BACK RIVER PROJECT
Responses to 2021 Annual Report Comments

28 September 2022

Sabina Gold & Silver Corp. (Sabina), submitted its 2021 Annual Report to the Nunavut Water Board (NWB) on 4 April 2022, as required by the Back River Gold Mine Project Certificate No. 007. Interested Parties were then requested by the NWB to provide comments on the 2021 Annual Report.

NWB-#01: Management Plans Updates.

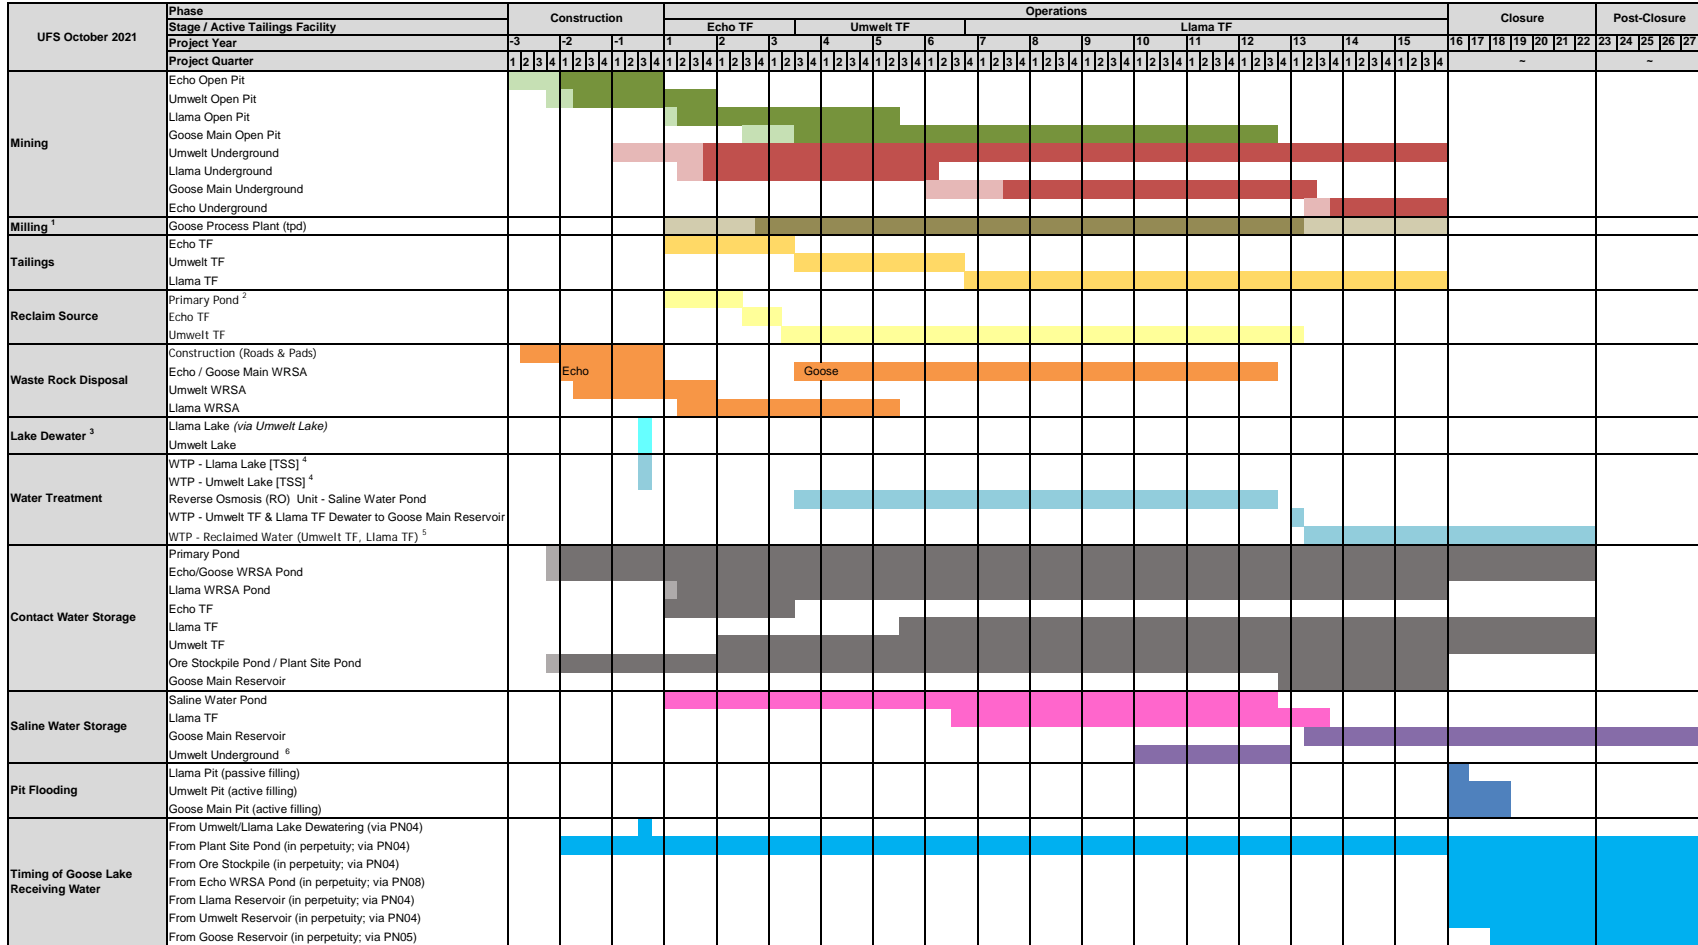
Provide a table listing all Management Plans modified in the reporting year and include the following information:

- Title of the plan.
- Most recent NWB Approval date (for approved plans).
- Most current update date.
- Brief description of the update including sections modified.
- Classification of the update (significant vs. insignificant as per Licensee).
- (Note that upon review of the plan, the Board will make their own determination of significance independent of the Licensee's suggestion).

Sabina Response:

Sabina will provide this information in future Annual Reports including the 2022 report.
